INFORMATION NOTE

N° 023/15

Implementation of a close dambar leadframe design for PG-DSO-36

Description of Change:

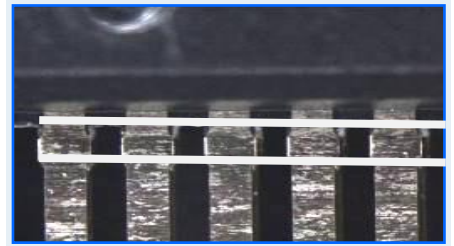
Subject of Change: Change of leadframe design to a close dambar design.

Old

New

Assessment: No impact on electrical parameters.
No impact for pick and place at board assembly expected.
